**Report to  
Development Permit Panel**

**File:** DP 03-230077

**Re:** **Application by Killick Metz Bowen Rose Architects Planners Inc. for a  
Development Permit at 4111 Bayview Street**

No. 1 ROAD  
SCALE: 1/8" = 1'-0"

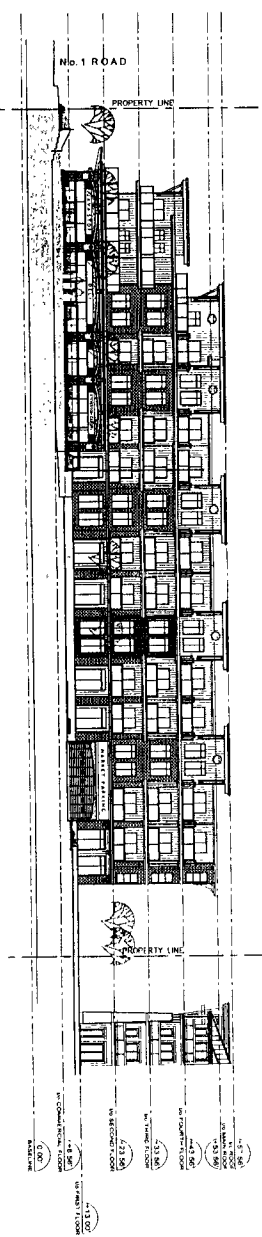
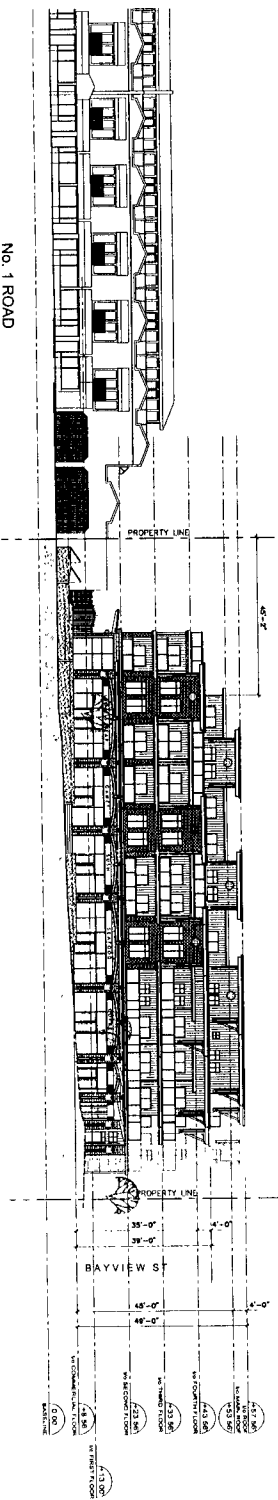
1. Allow a portion of the fourth floor to have a setback of 16.8 m (55.0 ft.) from the property line abutting No. 1 Road.

*(Staff support the proposed variance as it is only used to accommodate architectural appurtenances to articulate the top floor of the proposed building. The main building face of the fourth floor is setback to the required 20m (65.6 ft.). The living room “bays” project 3.2 m (10 ft.) into the 20 m setback. The most northerly “bay” projection occurs approximately 15.5 m (51 ft.) away from the north property line. In addition, the “bays” are oriented in a way that would not create overlook or privacy issues for the existing residential units to the north of the proposed development as the roof level of the existing development is used for parking purposes only. The applicant has modified the site plan to address street interface issues by increasing the setback at the ground floor, thereby creating a public plaza on the west and north sides of the building. These design improvements are important and significant, and compensate for the minor changes to the fourth floor setback proposed.)*

2. Allow a portion of the ground floor have a minimum 3.6 m (12 ft.) setback instead of the minimum required 4.3m (14.1 ft.).

*(Staff support the proposed variance. The building façade is well articulated and the majority of the building provides setback in excess of the minimum required. Only a small portion of this ground floor around the commercial elevator requires this variance.)*

3. Allow a portion of the veranda to have a minimum 2.1 m (7 ft.) setback instead of 3 m (9.8 ft.) from Bayview Street.

*(The covered veranda provides weather protection for pedestrians and a visual separation of the outdoor commercial area (for outdoor seating and display) from the street level without creating any negative impact on the adjacent developments.)*
